Board Work Session of the Board of Directors
BANKS SCHOOL DISTRICT 13
Banks, OR
Monday, May 11, 2026

1. Preliminaries
 - 1.1. Call to Order
 - 1.2. Roll Call
 - 1.3. Approval of Agenda
2. Discussion Items
 - 2.1. Bond Update
 - 2.1.1. Scope, budget and timeline
 - 2.1.2. DO documentary
3. Adjourn
4. Walkthrough Site Visit (Board Members only)

Banks SD – HVAV Refurbish Memo

TO: Brian Sica, Banks School District
FROM: Parker Verhaeghe, P&C Construction
DATE: April 16, 2026
RE: Banks HS — AHU 2 & 5 Desing, Noise Mitigations, Update & Options

04-02: Casework - 80% reduction of locks

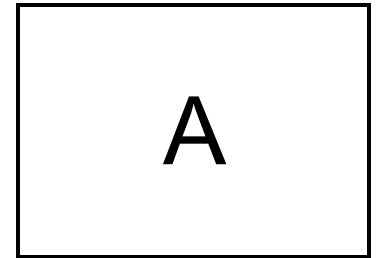
Pros	Cons
Cost Effective	
Keeps Teacher Locks in Scope Remove all other locks in General Classrooms and 1/2 the locks in Science Classrooms	
Allows for add back during future submittal review utilizing any potential contingency available.	
District Office - remove locks from Workroom	
Art Room - Remove half locks on west wall and all locks on casework on east wall.	
Staff Work Room remove locks.

Comments
Keep all locks in: Health Room, Graphics, Prep Room, Life Skills Room & DO Conference Room
